HEARINGS OFFICER HEARING - LAND USE: HOMAN OUTDOOR MOTOCROSS TRACK CONTINUANCE

FILE NUMBERS: 247-22-000812-CU / 247-22-000813-SP

1. **File Nos. 247-22-000812-CU / 247-22-000813-SP:** The applicant requests conditional use and site plan approval for a recreation-oriented facility requiring large acreage. Specifically, the applicant proposes a commercial outdoor motocross track.

Exhibit Site Plan

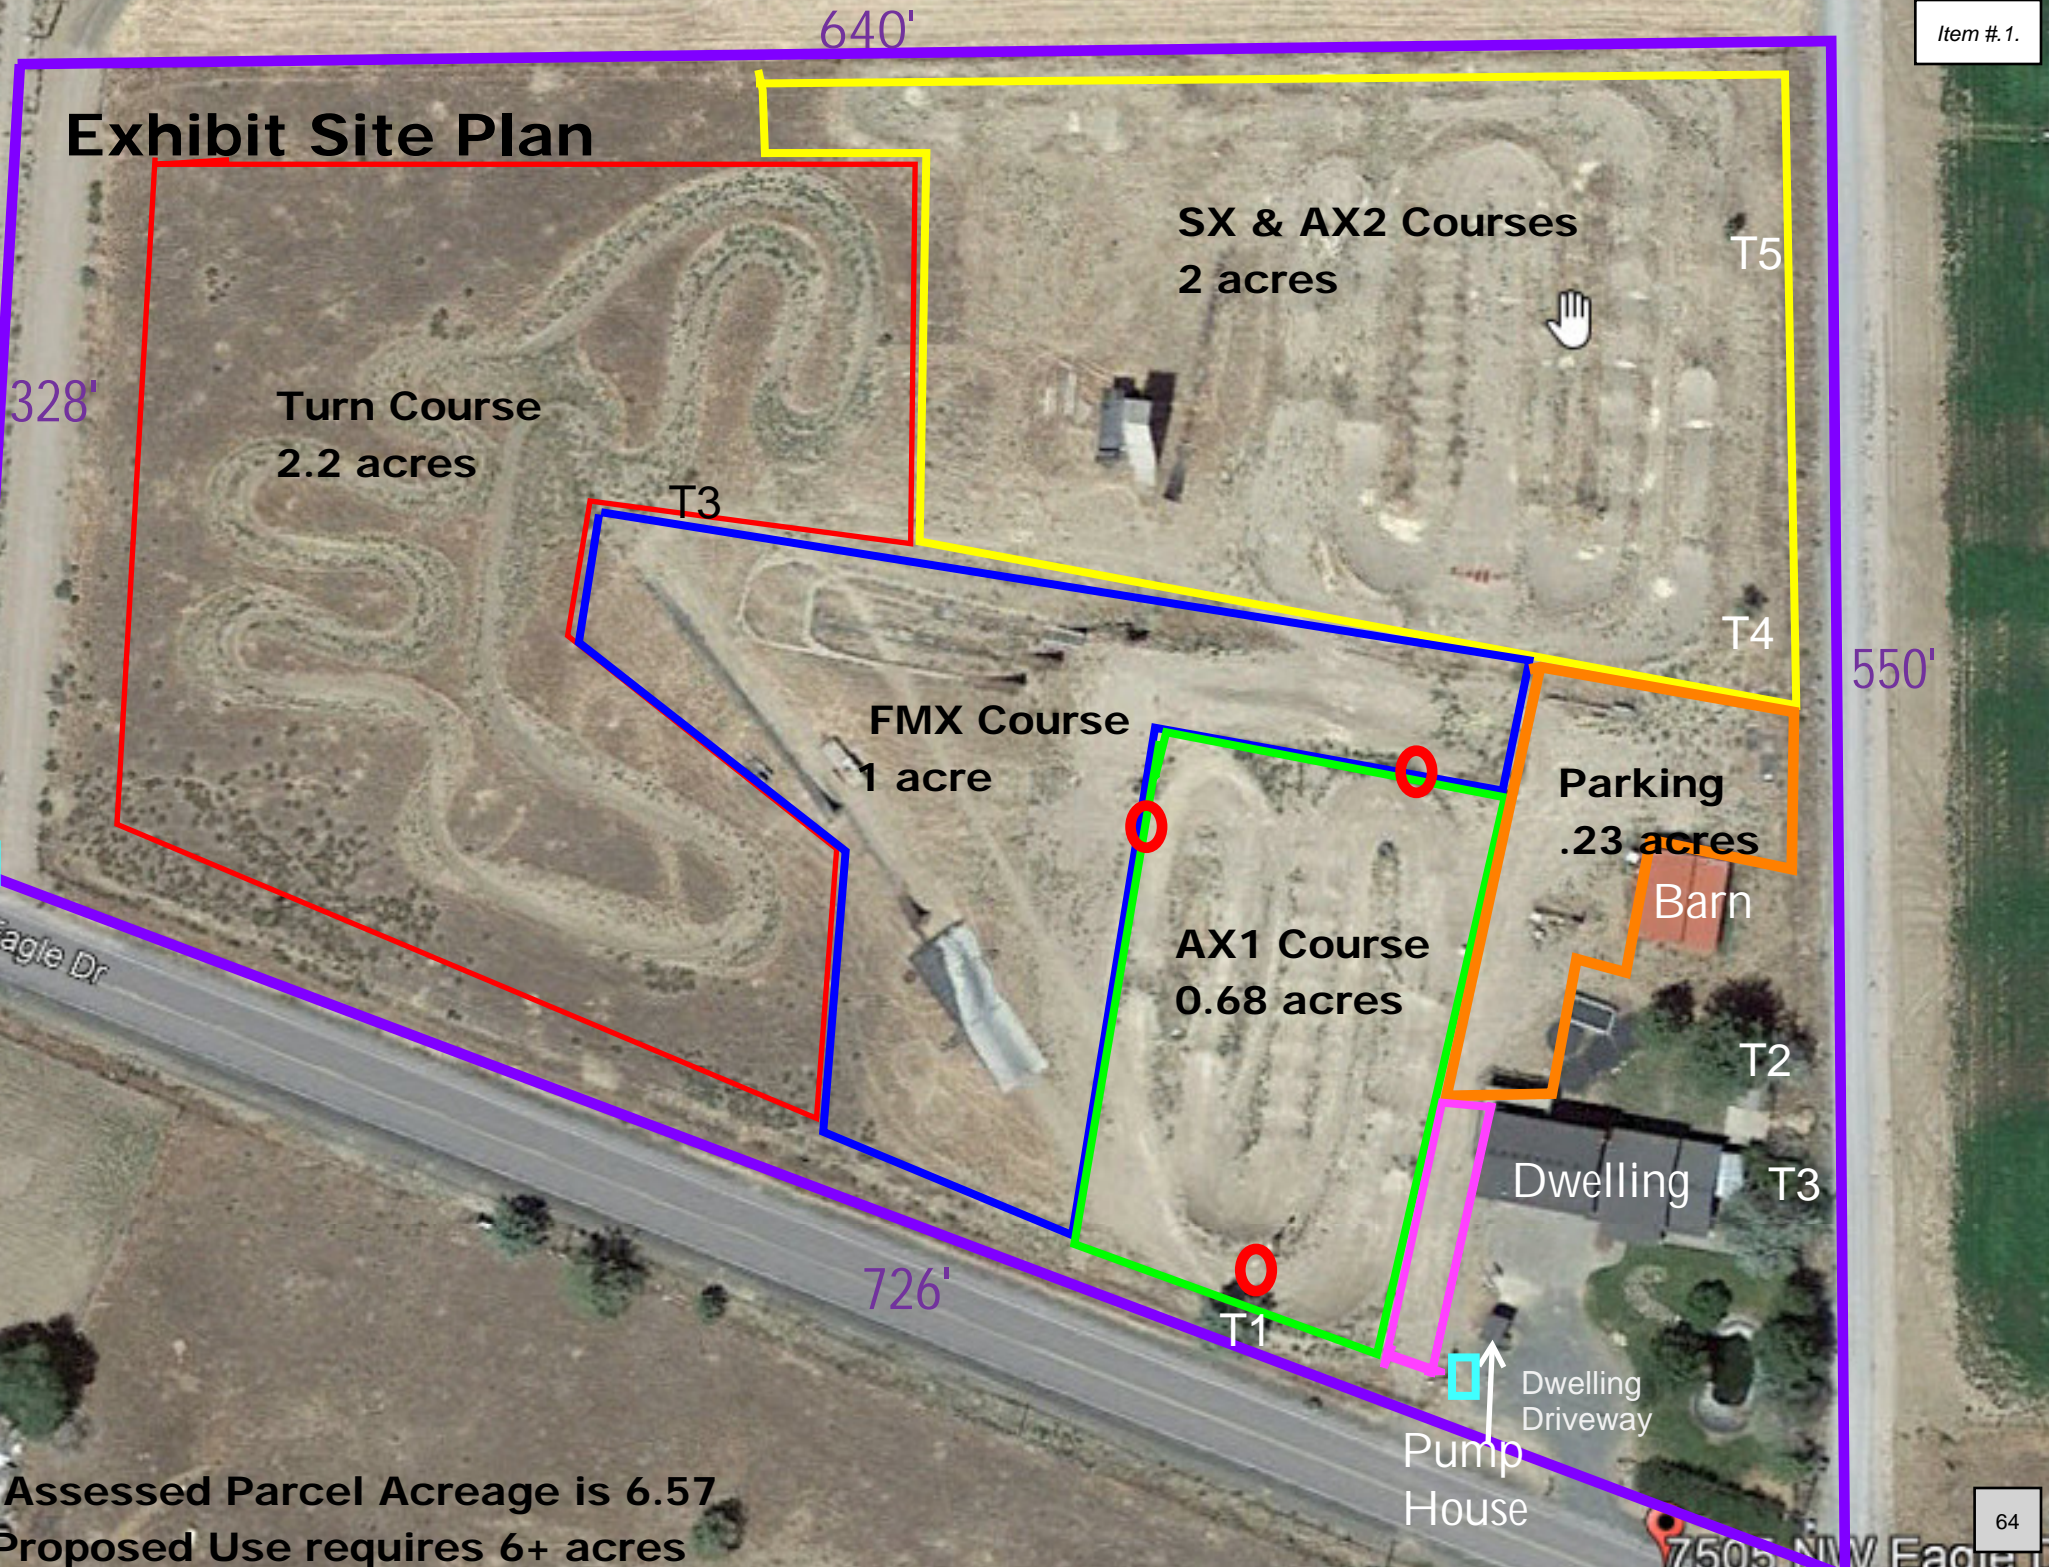
FINDING: The applicant proposes two-way access aisles, which requires a minimum width of 24 feet. The Applicant's site plan is not drawn to scale. Therefore, staff is not able to confirm the 24-foot aisle width will be met. Additionally, the areas identified for parking/access do not match on the various plans (see highlighted areas on Applicant's Exhibit Site Plan vs. Exhibit Site Plan Design). Staff asks the Hearings Officer to confirm if the Applicant has demonstrated compliance with this criterion.

However, as noted above, the site plan is not drawn to scale. For this reason, staff cannot confirm the minimum aisle widths are met. It is also unclear if or how pedestrian walkways have been integrated into the site plan. Typically, landscaping and walkways provide for a safe design for pedestrians on the site. However, these details are not included in the submitted materials or an explanation on why they are not required. For these reasons, it is not clear if the Applicant has demonstrated compliance with these criteria and staff asks the Hearings Officer to make specific findings on this issue.

FINDING: The applicant has not provided a drawn to scale site plan. For this reason, staff is not able to confirm the Applicant’s proposal complies with these criteria. The Applicant provided the following response on pg. 18 of the Burden of Proof Statement (Amended 3.23.2023):

EXHIBIT "SITE PLAN DESIGN (TRAFFIC FLOW)

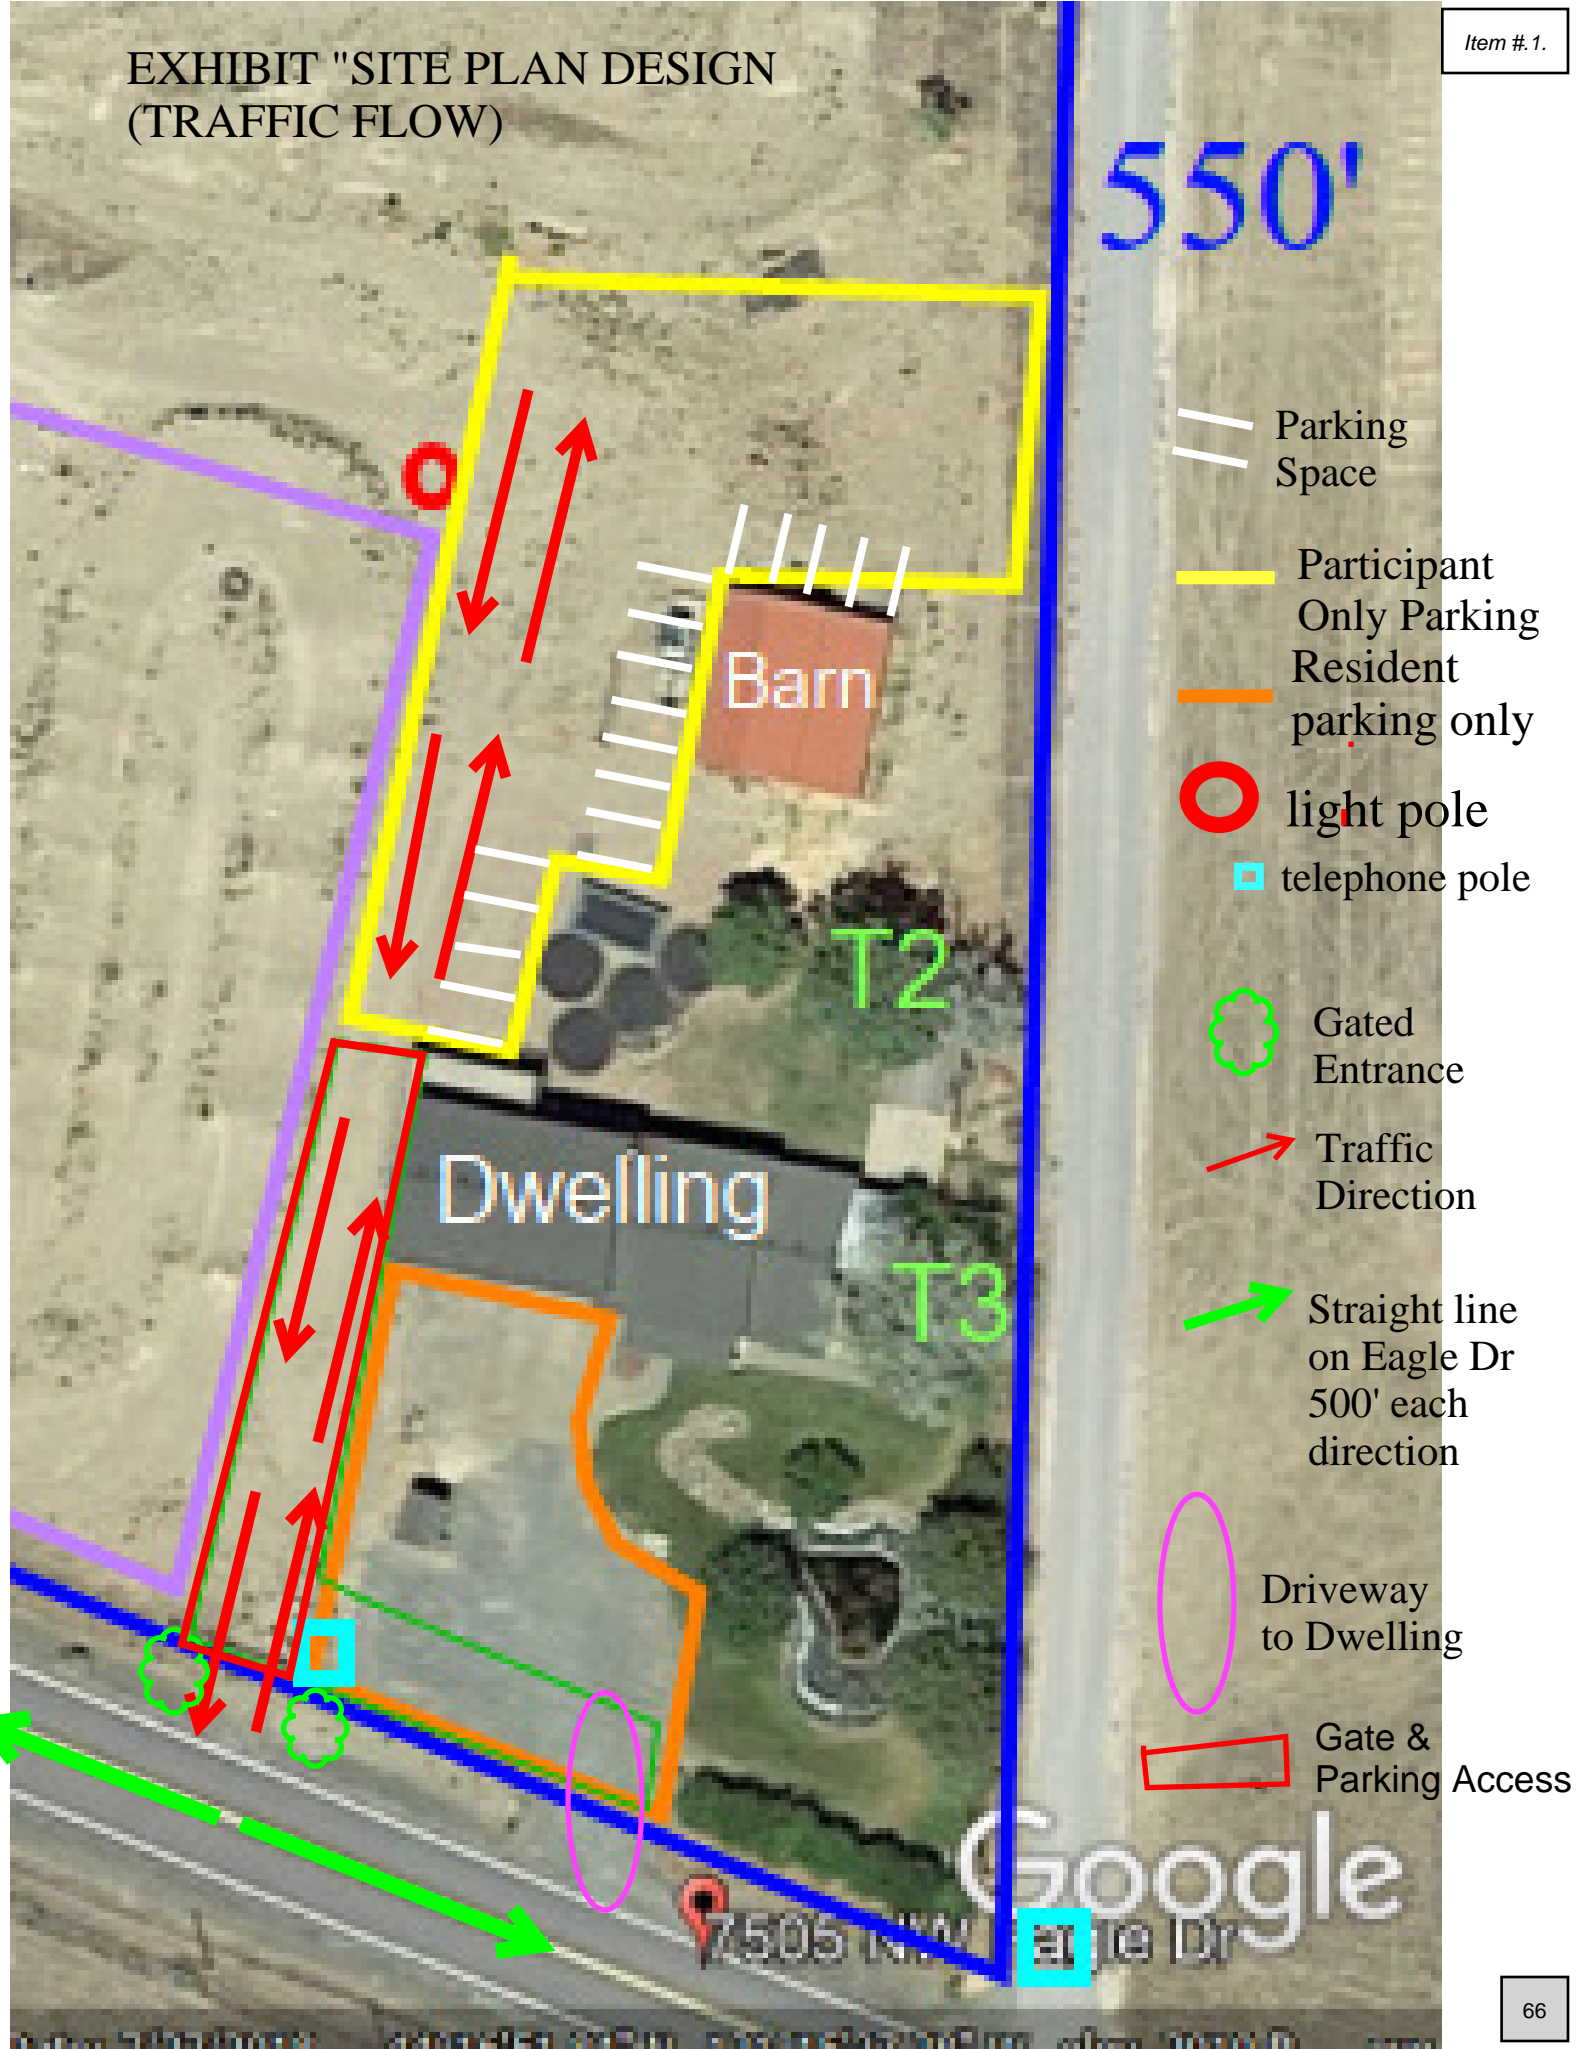
FINDING: The Applicant’s Exhibit Site Plan Design (Traffic Flow) shows there will be five (5) parking spaces on the north side of the existing barn. As noted in the Basic Findings section, the property abutting the north property line is developed with a single-family dwelling. The applicant argues, and staff agrees, that the proposed course obstacles will screen or buffer these parking spaces from this adjacent residential use (see Exhibit Course Obstacles and *Figure 9* below).

FINDING: The Applicant’s Exhibit Site Plan Design (Traffic Flow) shows the northeastern portion of the participant-only parking area will be adjacent to a lot line. However, the site plan is not drawn to scale and staff could not identify any proposed landscaping in this area. Therefore, staff asks the Hearings Officer to determine if the Applicant had demonstrated compliance with this criterion.
